## Re-Opened Public Enquiry into Application PP/D2320/W/22/3295556 March 2024

This Submission covers the following two issues

- A581/Ulnes Walton Lane Mitigation
- Construction Phase Impacts

Response MoJ Submission using Headings of the documents

Appendix B South Bound Bus Stop on Ulnes Walton Lane by Care Home

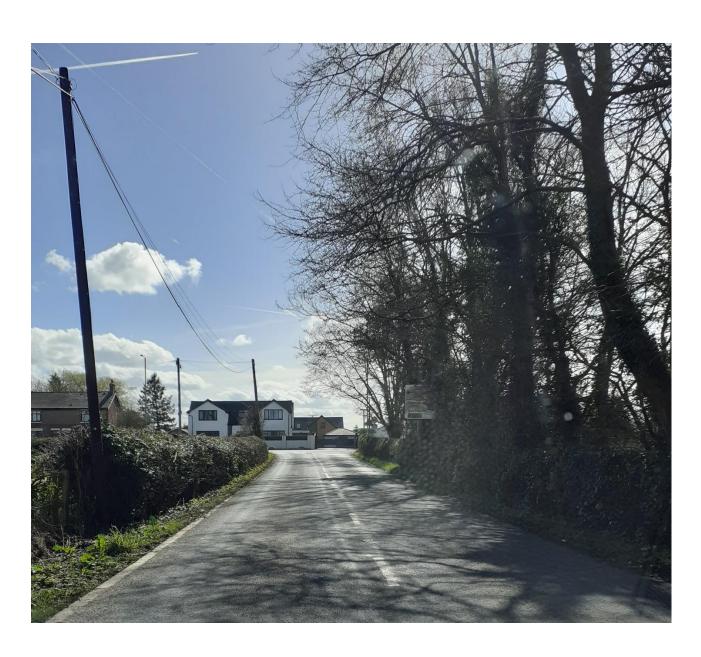
As recognised by all parties there is no footpath on Ulnes Walton Lane and anyone using the Bus Stop will necessarily have to walk in the road and this is unchanged despite the increased traffic volume and no mitigations
	The risk to pedestrians existing or accessing Ulnes Walton Lane in respect of conflict with Cars and HGVs at the junction with the A581 has not been addressed. As shown in the photograph in Appendix C, Ulnes Walton Lane is narrow with no footpaths. In the event of queuing of vehicles waiting to exit Ulnes Walton Lane (As forecast in the MoJ model), pedestrians will have no choice to approach the Junction in the face of traffic turning into Ulnes Walton Lane and will have to fling themselves into the hawthorn hedge on the west side of the road to avoid a life threatening conflict with on-coming vehicles. Surely this is not a matter to be overlooked in granting the MOJs Appeal.

Photograph looking North (Opposite Care Home) ,Showing Bus Stop on eat side and Public Footpath sign. No protection for Pedestrians is proposed
